PLANNING REPORT

Board of Zoning Appeals

Kaufmann Residence 25-120V

Address	4700 Deer Run Drive, Dublin, OH 43017
Proposal	Request for review and approval of three Non-Use (Area) Variances to allow for a new single-family home to deviate from the Residential Appearance Standards and to allow for a detached garage to encroach into the front yard.
Request	Review and approval of a Non-Use (Area) Variance under the provisions of Zoning Code Section 153.231(H).
Zoning	PUD, Planned Unit Development - Deer Run Estates
Planning Recommendation	<u>Approval of three Non-Use (Area) Variances</u> <u>Disapproval of one Non-Use (Area) Variance</u>
Next Steps	The Board of Zoning Appeals (BZA) is the final reviewing body for this application. If approved by the BZA, the applicant may apply for a building permit.
Applicant	Megan Odenweller, Memmer Homes
Case Manager	Tori Brubaker, Planner I (614) 410-4632 tbrubaker@dublin.oh.us

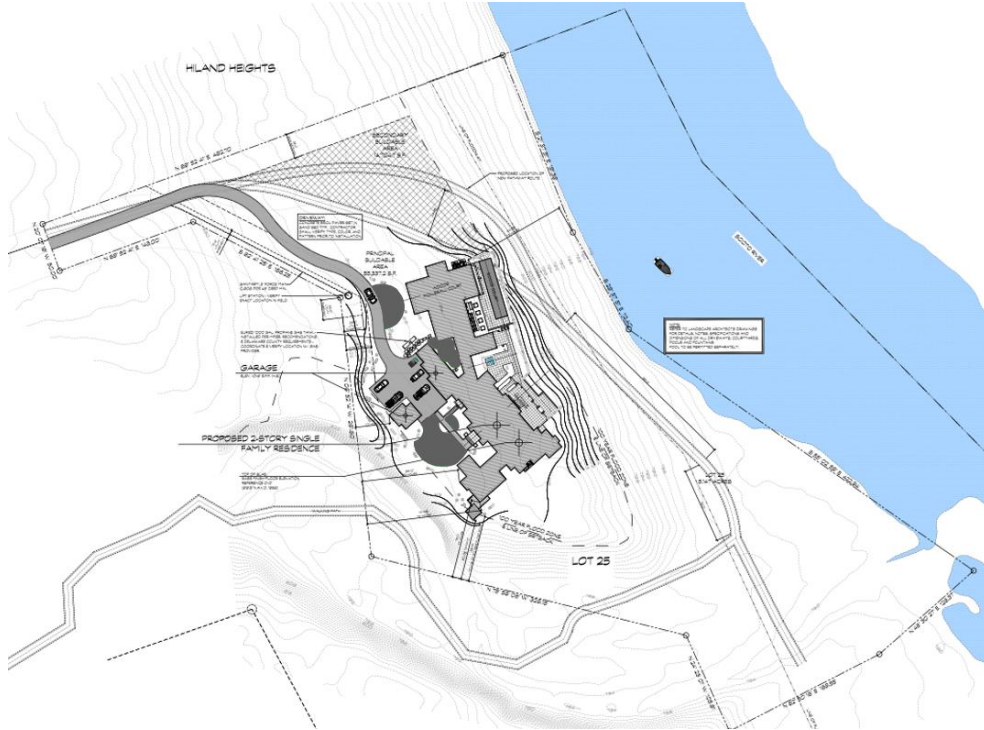
The site variance is to permit an approximately 500-square-foot garage forward of the primary structure. Detached accessory structures are required to be located to the side or rear of the principal structure on a residential site. The applicant has stated that this request is due to the several site constraints that limit the location of the garage on the site.

Criteria A	Review
	<p>#3 (Garage Door Width) – Criterion Not Met: The Variance is requested due to the action of the applicant pursuing a total width of garage doors that is wider than permitted. The Variance could be avoided if the width of the doors were reduced to meet zoning code requirements. This request differs from the roof and trim requests as the amount of garage doors is not indicative of the architectural style requested for the home.</p> <p>#4 (Accessory Structure Location) – Criterion Met: The applicant has not created the natural conditions of the site and has not exacerbated the conditions of the site. The conditions of the site and the determination of the front property line limit permissible locations for detached structures on the site.</p>

Criteria A	Review
	#4 (Accessory Structure Location) – Criterion Met: The request for a detached structure that is generally located to the side of the home would not infer special privilege to the property owner. Similar requests due to natural features have been granted to other property owners in the City.

4. The practical difficulty could not be eliminated by some other method, even if the solution is less convenient or most costly to achieve.	#1, 2 (Appearance Standards) - Criterion Met: The design components that the applicant is proposing are indicative to the architectural style and the success of the style proposed. #3 (Garage Door Width) – Criteria Not Met: The combined width of the garage doors could be reduced by two feet to meet the requirements of the code. #4 (Accessory Structure Location) – Criterion Not Met: The garage could be relocated to the north side of the property to meet the requirements for detached structures

Planning Staff recommends **Approval** of the Non-Use (Area) Variance to Zoning Code Section 153.074(B)(6)(a) to permit a detached garage to be forward of the primary dwelling.
